Canada and United States of America

Comments for Battery External Fire Safety

As an action item from the 9th EVS IWG meeting, we are submitting the U.S. and Canada's position on fire exposure test. We would like to provide the following recommendations to TF-7 for consideration:

Thermocouples Positioning (Christmas Tree)

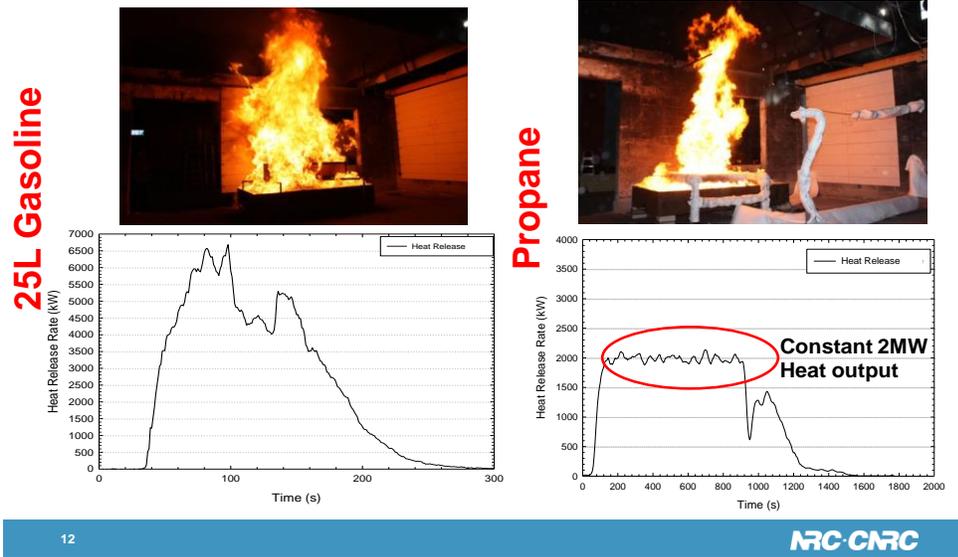
- Battery packs suspended over a propane sand burner, previously calibrated with gasoline to simulate a gasoline pool fire.

Calibration – Flame Temperature

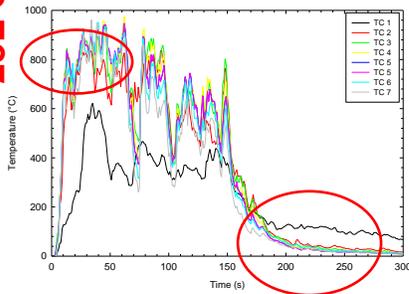
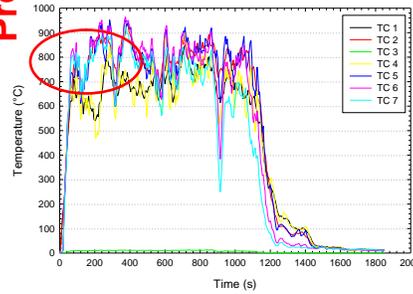
Temperatures TC 1 are taken as close as possible from the top of the battery packs. Note that the temperature TC 1 from the gasoline graph is much lower than TC 1 from the propane graph. This demonstrates that, at a close distance from the pack, the gasoline does not generate the same heat release rate as the propane. A more accurate measure of the potential impact of the fire on the battery is the temperature measured near the battery surface per UL 2580 as this determines the radiative heat flux to the battery. Another approach is to measure the incident heat flux to the battery. However, this can be difficult to measure in a flame environment.
